STANDARD DEPARTURE CHART-INSTRUMENT

RJFN / NYUTABARU

NIPPO SEVEN DEPARTURE

SAITO ONE DEPARTURE

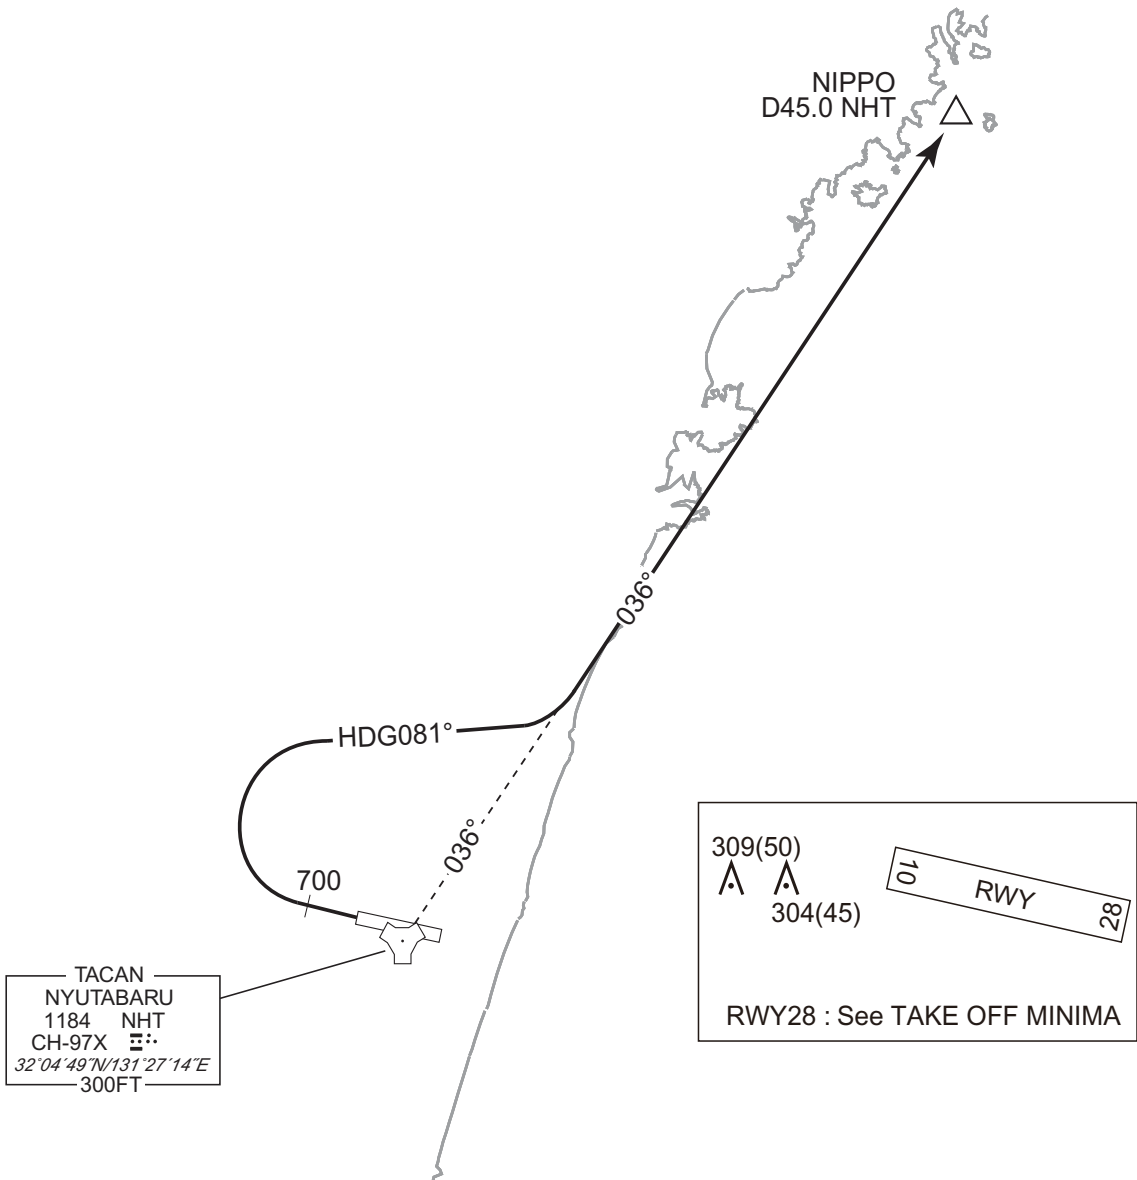
CHANGE : New PROC.

TRANSITION

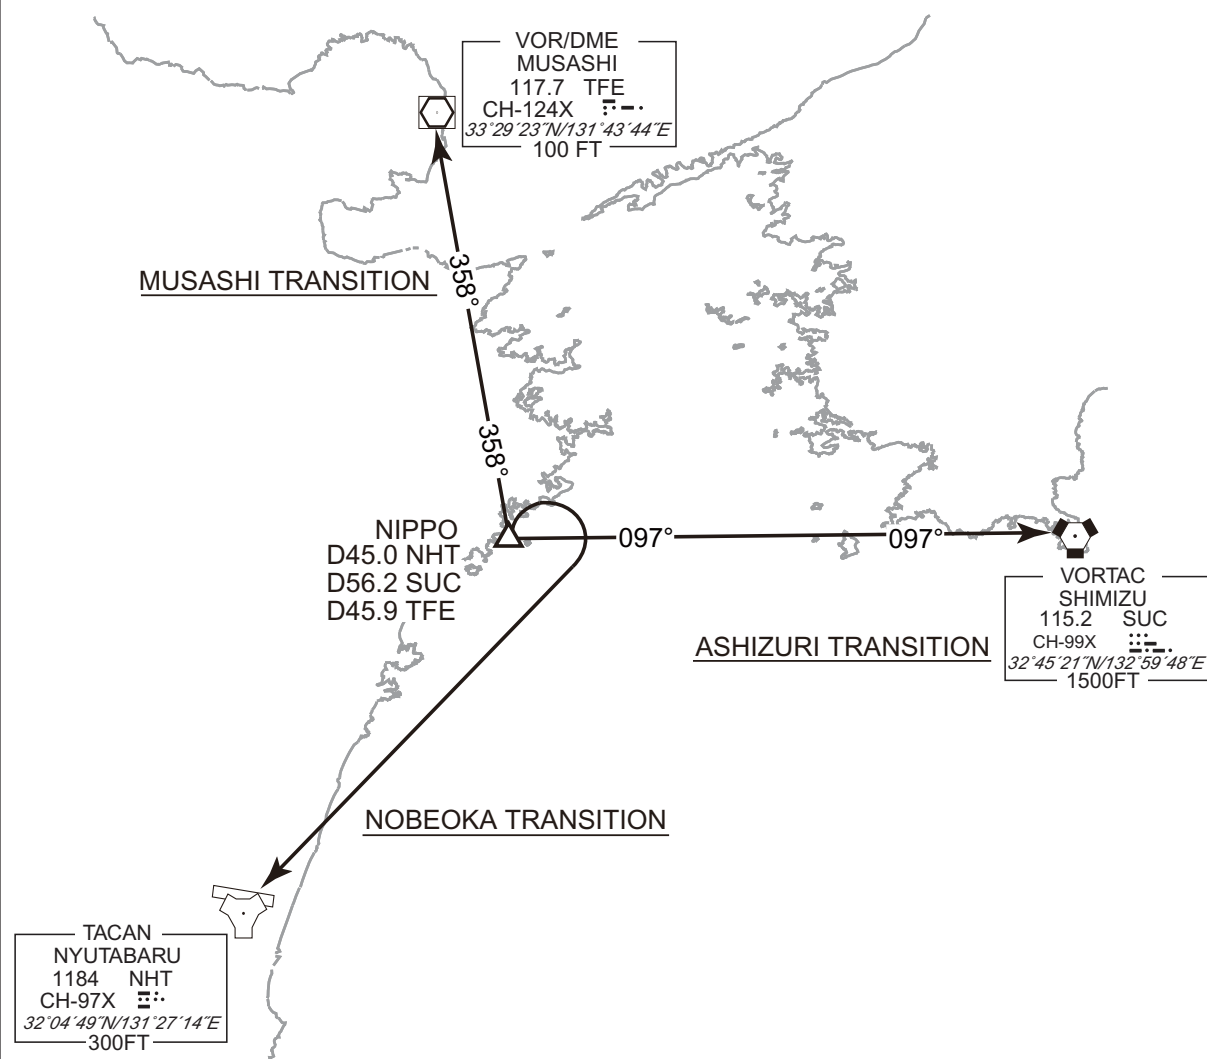
CHANGE : PROC course(NOBEOKA TRANSITION). Description of ASHIZURI TRANSITION, MUSASHI TRANSITION, MUSASHI TRANSITION. ALT restriction.
SOBO TRANSITION abolished.

TENSO ARRIVAL

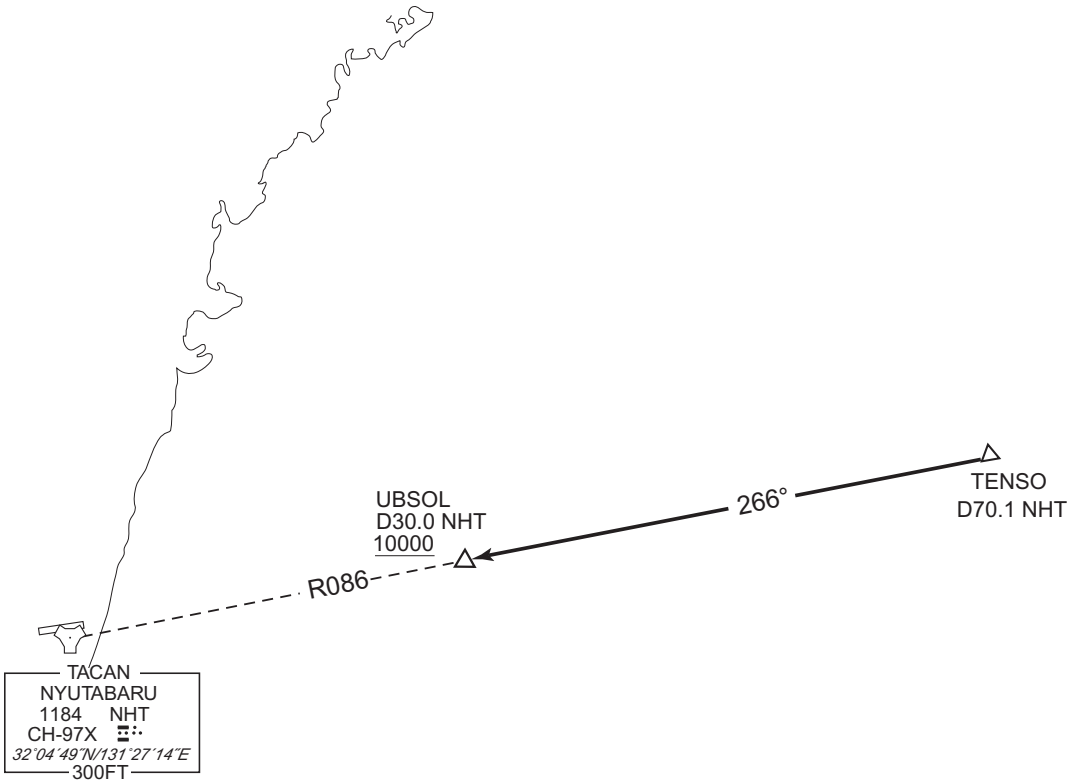
CHANGE : PROC course. UBSOL established. ALT restriction.

TACAN Z RWY28

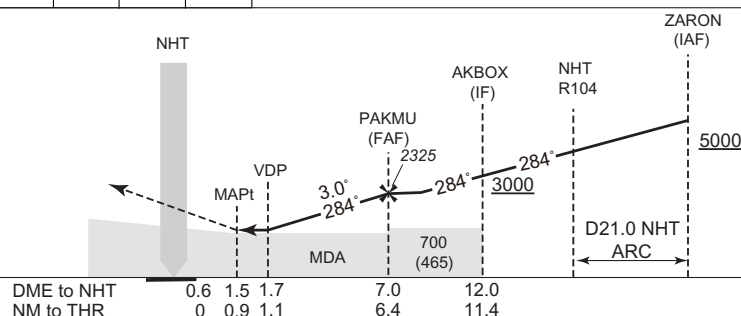
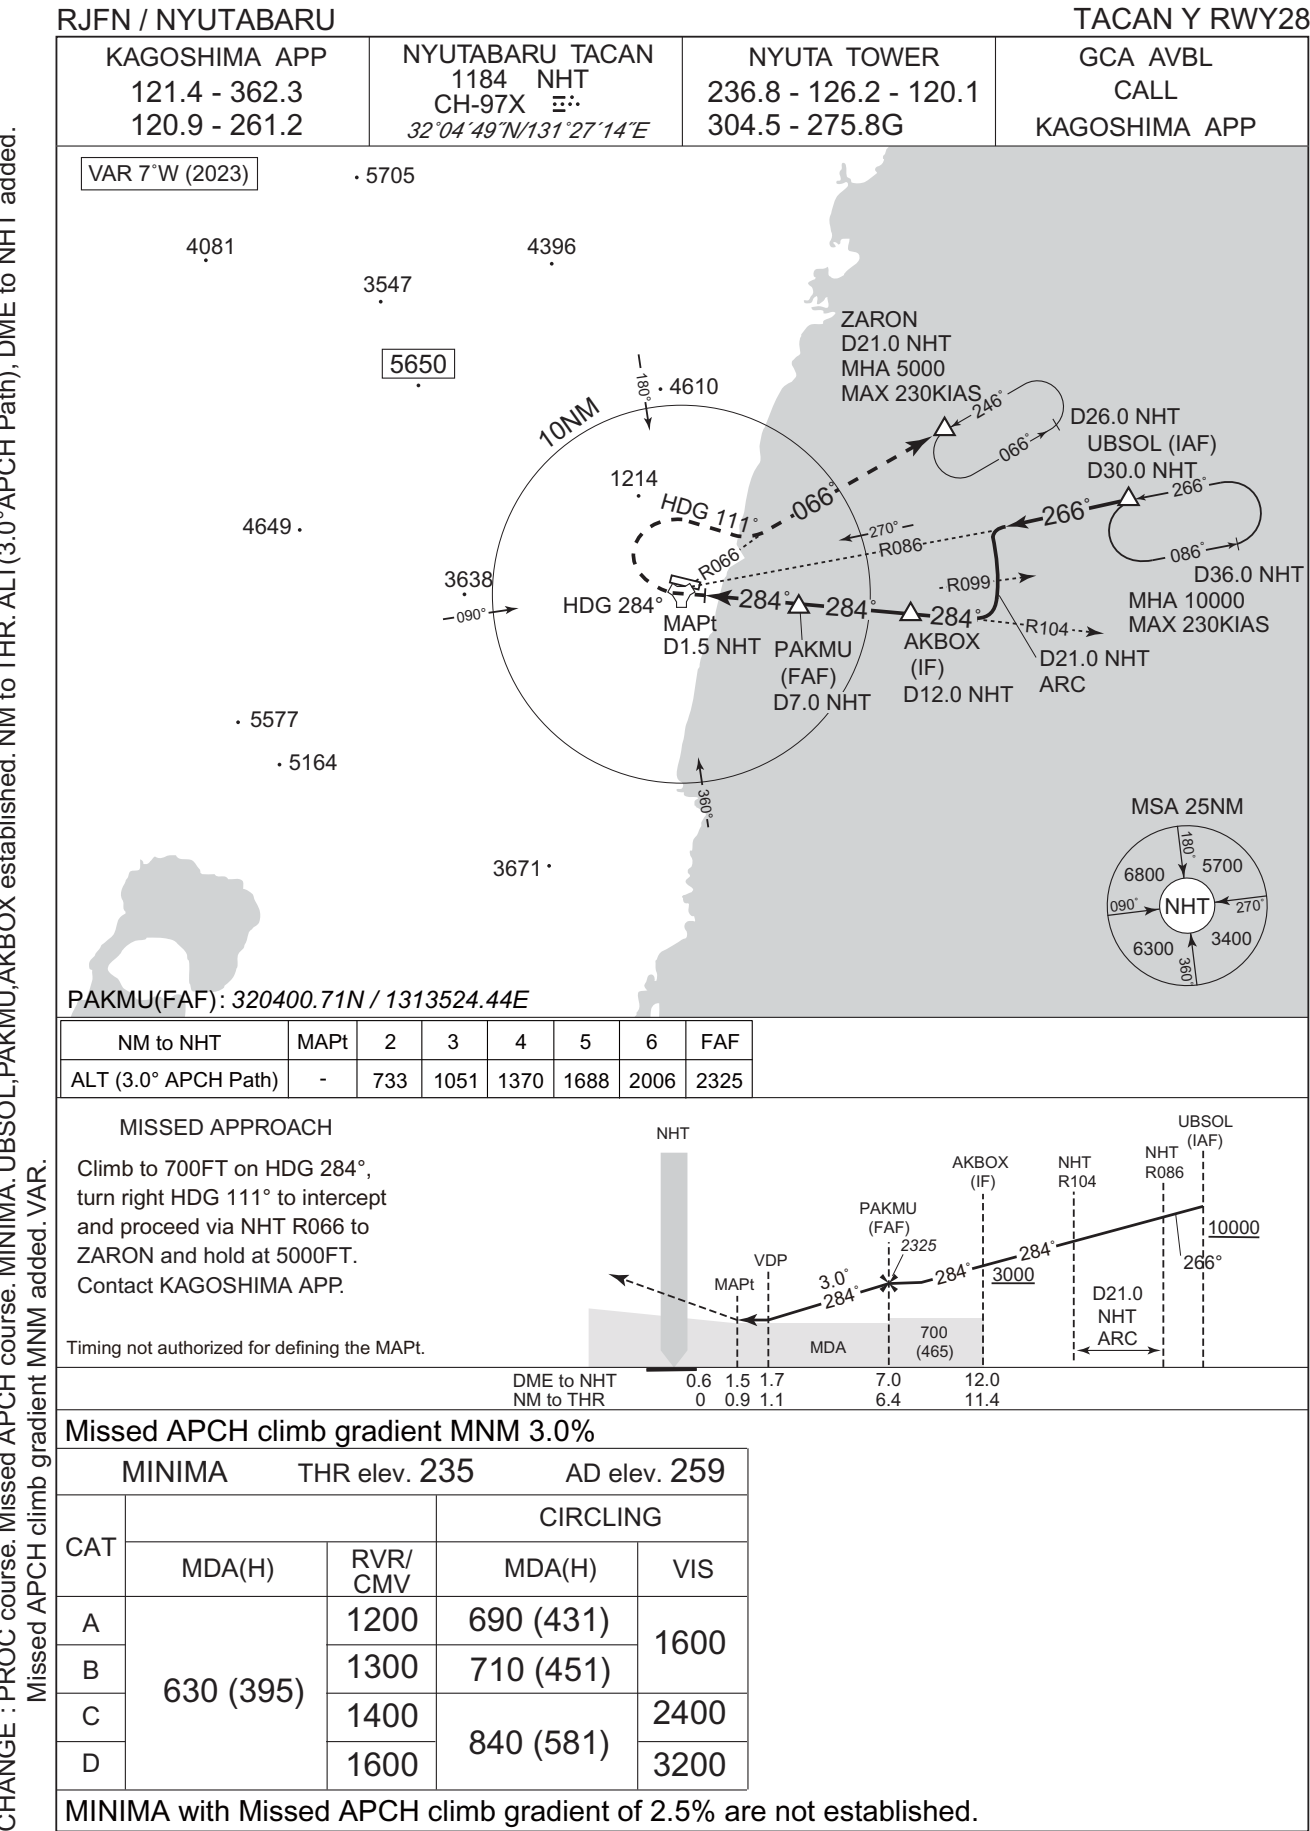
CHANGE : PROC course. Missed APCH course. MINIMA. PAKMU,AKBOX established. NM to THR.ALT(3.0°APCH Path), DME to NHT added. Missed APCH climb gradient MNM added. VAR.

ILS Y or LOC Y RWY28

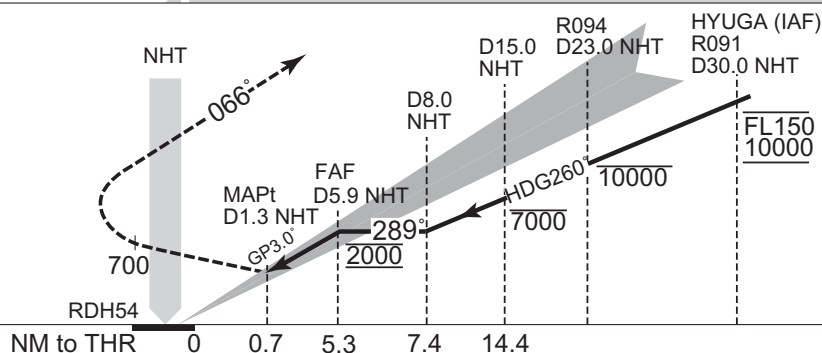
CHANGE : VAR. PROC renamed. EQPT REQUIRED added. PROC course. MISSED APPROACH course. MSA.
NM to THR added. MDA(H) for CIRCLING.
